Jan. 23rd,2018

This letter is to in response to your mail dated on Jan 23rd, 2018 regard about second request for additional information for our exempt distribution license.

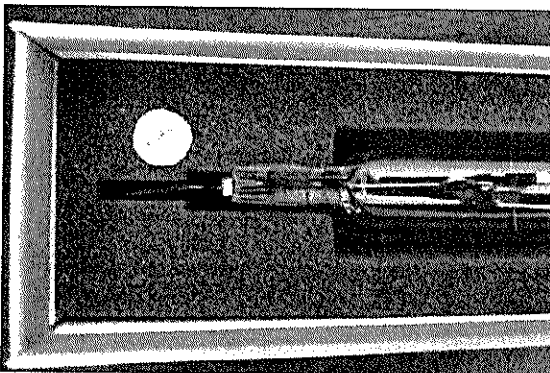
3. Please provide the appropriate units of each drawings, translate written text into English of the drawings and specify whether each drawing identifies a particular lamp model, or a series containing lamps that are similar but have varying model numbers.

Please noted that all units of the drawing is mm(millimeter).

I will translate all the written text into English in attachment.

We have four series under Arc Tube-Quartz bulb, each series contains 3 different models. These models are very similar but have varying model number which is 4K,6K and 10K. 4K,6K and 10K is also refer to the spectrum of the bulbs.

We have five series under Arc Tube-Ceramic Poly crystalline bulb,each series contains 1 to 3 different models. These models are very similar but have varying model number which mainly is 3K, 4K and 3KR. 3K,4K and 3KR is also refer to the spectrum of the bulbs.

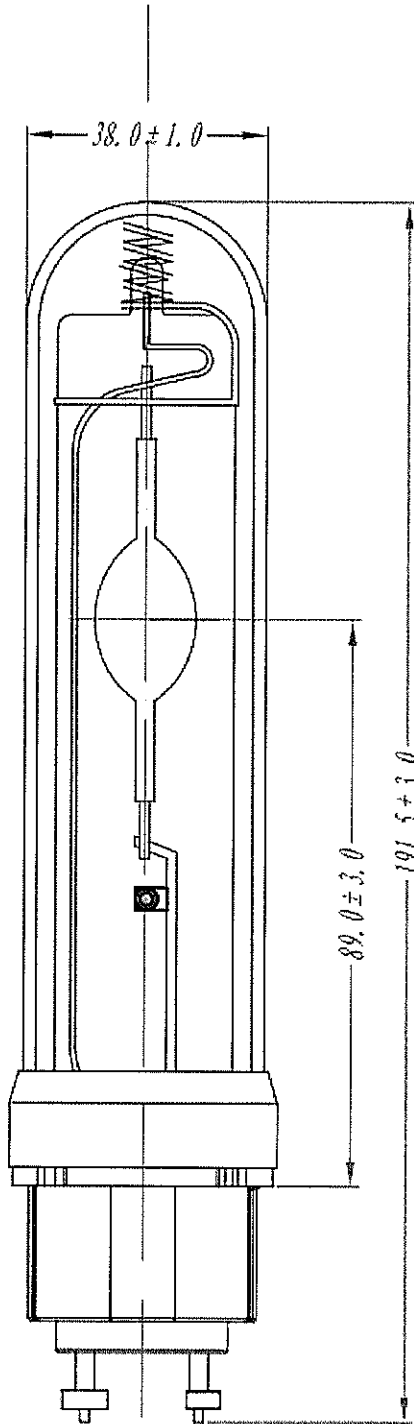
5. Please provide examples of your labels in the form of drawings, copies, or photographs.

I am attaching a picture with Kr-85 labeling on the bubble pack containing the electron tube.

All product containers are labeled with "Contains Kr-85" or "Arc Tube Contains Kr-85". All defective or broken product will be isolated in a dedicated area of the facility and disposed of properly. It would not be transfer to any other facility or users. Given the very low activity of Kr-85 stored and being a chemically inert gas, radioactive waste is not expected to be generated at the TOP SHELF facility.
